Attachment 1

<u>Unit 2</u>	<u>Revision</u>
Page 2-2	Replace
Page 2-5	Replace
Page 2-8	Replace
Page 2-9	Replace
Page 3/4 2-15	Replace

EVALUATION OF SIGNIFICANT HAZARDS CONSIDERATION

Figure 2.1-1 Reactor Core Safety Limit
Three Loops in Operation

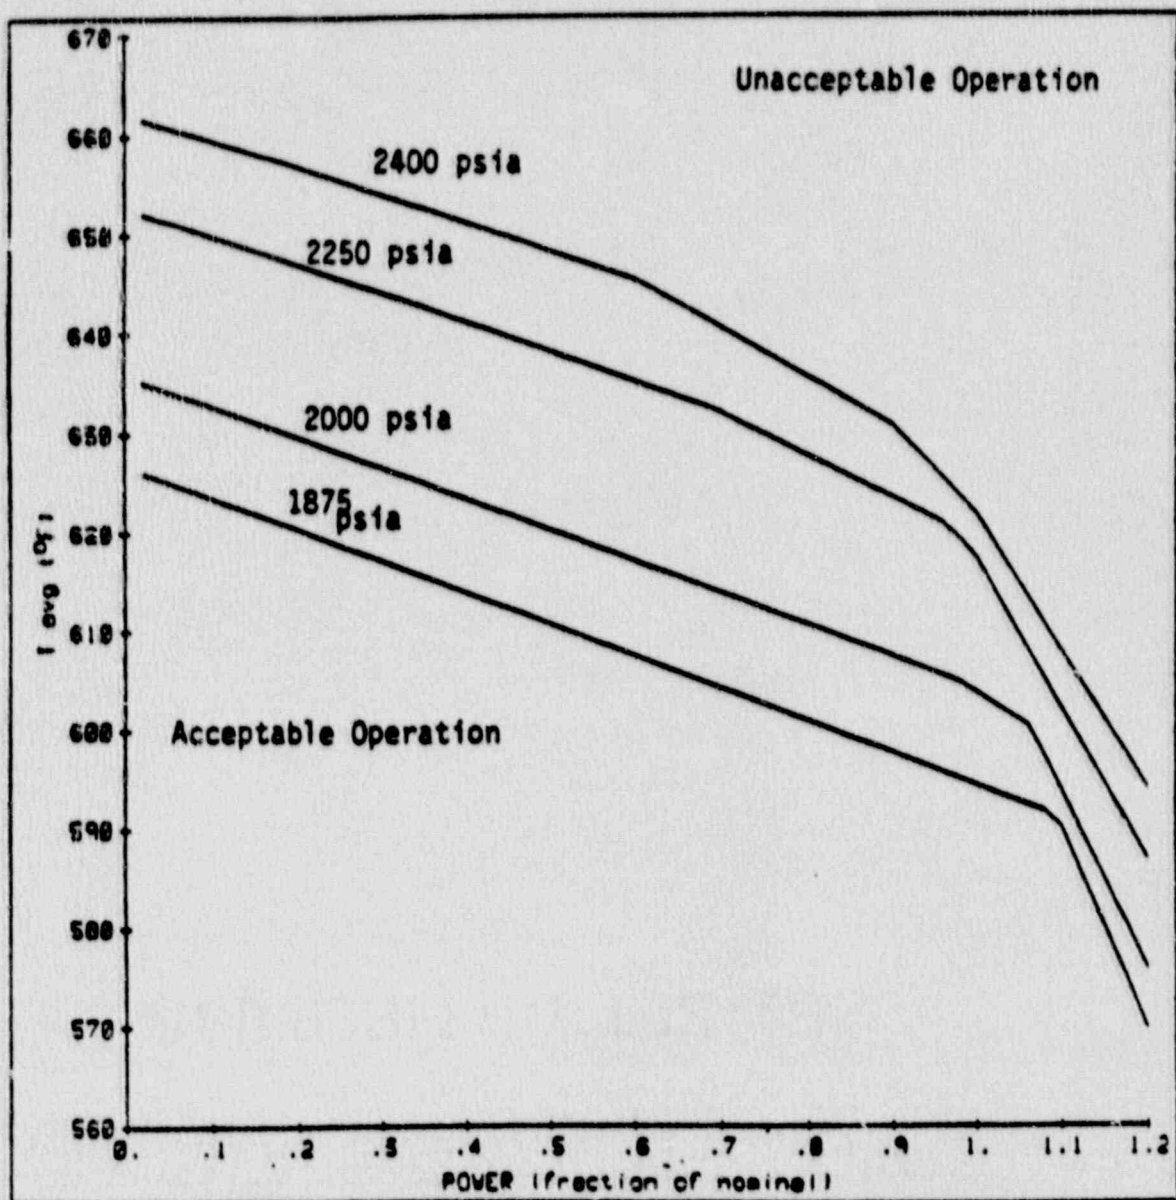
The proposed amendment involves an increase in equivalent plugging limits from the current licensed value of 10% uniform plugging to a new licensed value of 15% average with a 20% peak in any one steam generator. Also included is a decrease of approximately 1.5% in Reactor Coolant System (RCS) total flowrate from the current licensed value of 265,500 gpm to a new licensed value of 261,600 gpm. As discussed in WCAP-12659, a comprehensive evaluation of the effects of the increased tube plugging and reduced RCS flowrate has been completed, and no adverse safety implications have been identified.
